Docket Number:	18-IRP-01
Project Title:	Integrated Resource Plan
TN #:	230469
Document Title:	Review of Imperial Irrigation District 2018 Integrated Resource Plan
Description:	** This document supersedes TN# 230264 for accessibility purposes **
Filer:	Courtney Wagner
Organization:	California Energy Commission
Submitter Role:	Commission Staff
Submission Date:	10/31/2019 4:28:01 PM
Docketed Date:	10/31/2019

STAFF REPORT

Review of Imperial Irrigation District 2018 Integrated Resource Plan

Figure 1: Imperial Irrigation District and CEC Forecasts 2018-2030 (GWh)

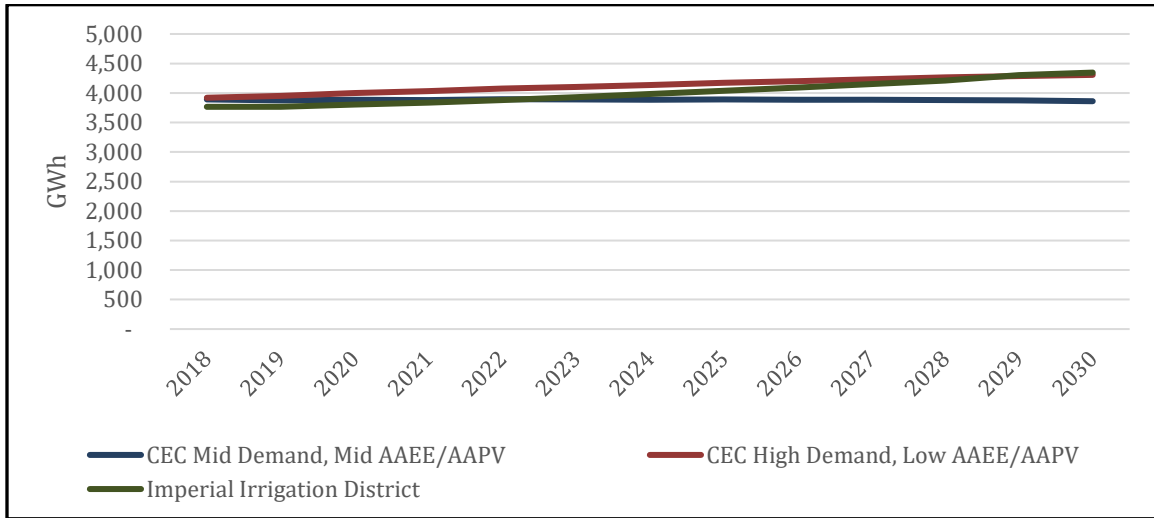
IID's energy demand forecast (expected case) is similar to the Energy Commission's demand forecasts (*California Energy Demand 2018 to 2030 Revised Forecast*).¹¹ The IID forecast lies between the Energy Commission's *mid-demand forecast* that includes mid-levels of additional available energy efficiency

By 2030, the IID energy demand forecast is almost identical to the Energy Commission's *high demand forecast*, with IID's forecast 39 gigawatt-hour (GWh) higher in 2030, less than 1 percent. In the same year, IID's energy demand forecast is 485 GWh higher than the Energy Commission *mid demand forecast*, a 12 percent difference that is adequate in a long-term planning context. **Figure 1** compares IID's energy demand forecast to those of the Energy Commission.

Figure 2: Imperial Irrigation District and CEC Peak Forecasts (MW)

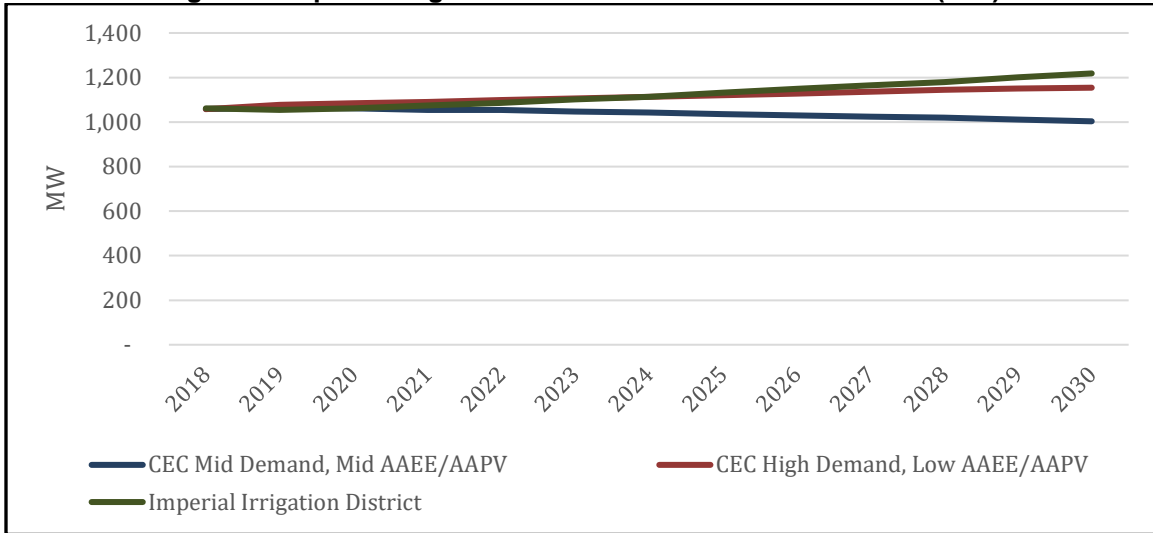
Similar to its energy demand forecast, IID's peak demand forecast (expected case) shows an annual average increase of 1.2 percent from 2019 to 2030. The utility's peak demand forecast is almost identical to the Energy Commission *high demand peak forecast* from 2018 to 2025, then starts to exceed it from 2026 to 2030. By 2030, IID's peak demand forecast is 64 MW, or about 5 percent, higher than the Energy Commission's *high demand peak forecast*. This difference is adequate in a long-term planning context. **Figure 2** compares the IID peak forecast to those of the Energy Commission.

IID planned for the possible influx of large commercial customers into its service area that would increase its load, which may explain why IID's demand forecasts are closer to the Energy Commission high demand forecasts.

Figure 3: Sources of Renewables Portfolio Standard Eligible Energy (MWh)

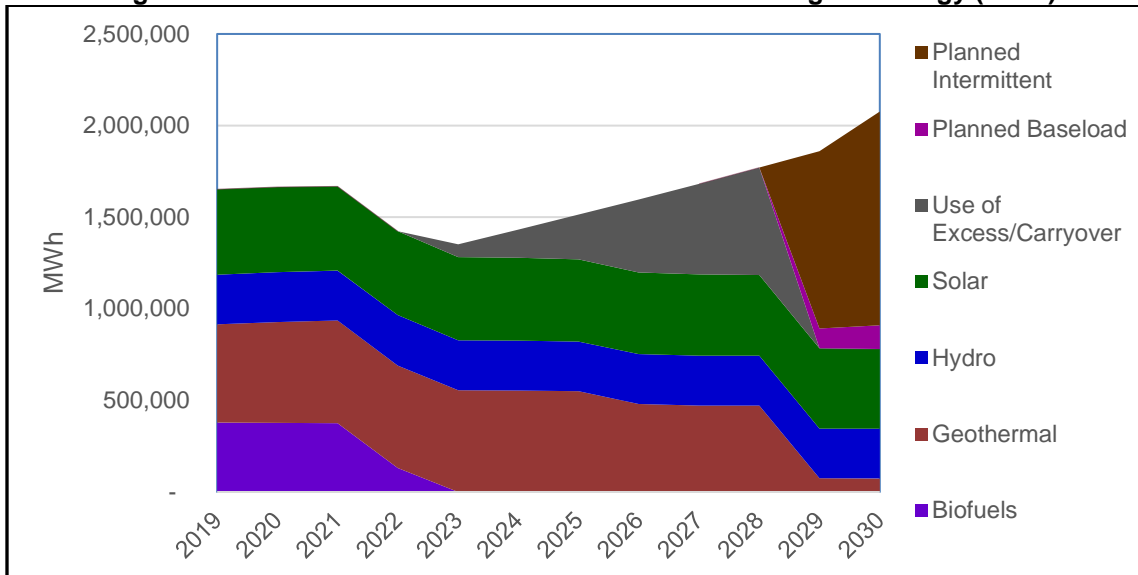
renewable procurement standardized reporting table, the discussion in the IRP filing, and the renewable procurement plan submitted. Staff finds that IID's plans are consistent with the RPS procurement requirements in 2030 and all interim compliance periods and are consistent with requirements of PUC Section 9621(b)(2).

Meeting a 50 percent RPS target requires that IID procure more than 2,000 GWh of RPS-eligible energy between in 2030.¹⁶ The utility plans to meet interim procurement requirements by procuring surplus amounts of RPS-eligible energy from 2019 to 2022 and banking the associated Renewable Energy Credits (REC) to cover shortfalls in energy procurement in 2024 to 2028. Additional energy from renewable resources in 2029 and 2030 would meet RPS requirements in the final compliance period from 2028 to 2030. **Figure 3** shows sources and amounts of RPS-eligible renewable resources from 2019 to 2030. Additional detail on annual RPS-eligible energy procurement and the banking and retirement of RECs for the planning period can be found in the RPS standardized reporting table (see **Appendix B**).

Figure 4: IID Renewables Portfolio Standard Mix in 2019 and 2030

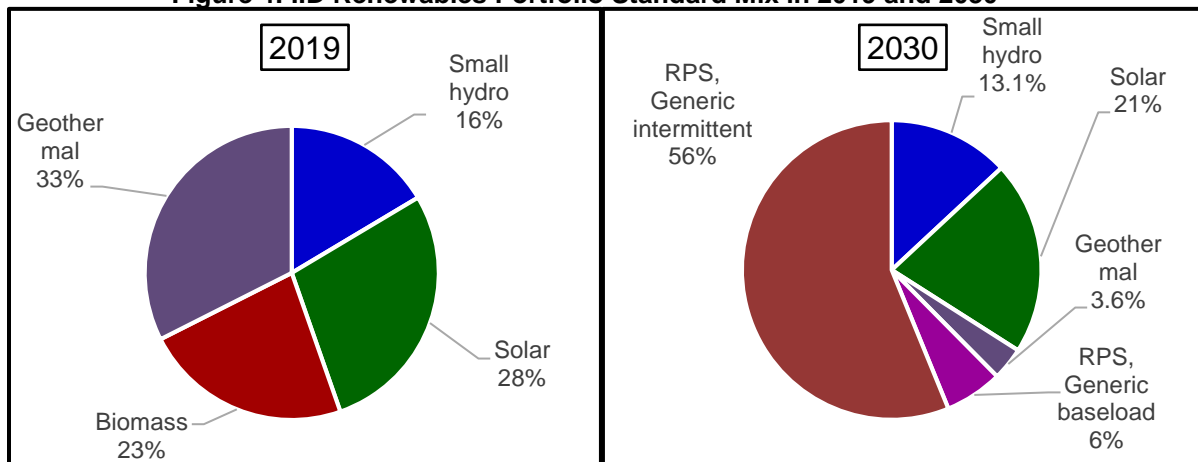
As shown in **Figure 4**, in 2019, the utility has roughly 70 percent baseload and 30 percent intermittent renewable resources. By 2030, IID's renewable resource mix consists mostly of contracted resources, and new renewables procured in 2029-2030 are roughly 90 percent intermittent and 10 percent baseload. IID's renewable resource mix, in 2030, includes:

Figure 5: IID's Portfolio Comparison for 2019 and 2030

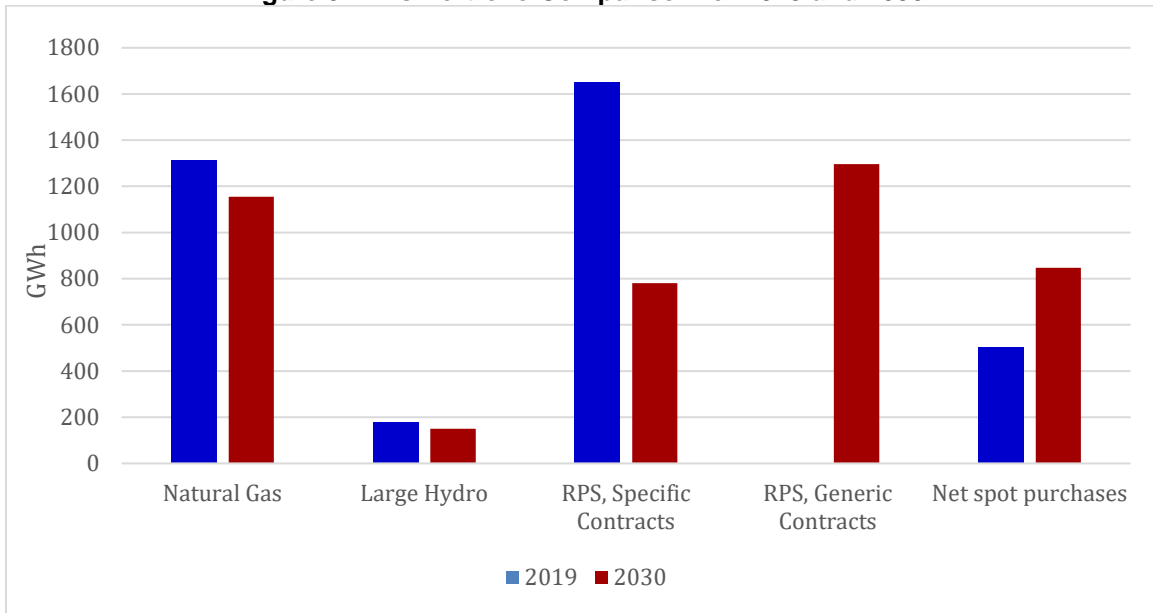
Figure 5 shows a comparison of the energy mix by resource in 2019 compared with IID's preferred portfolio in 2030.
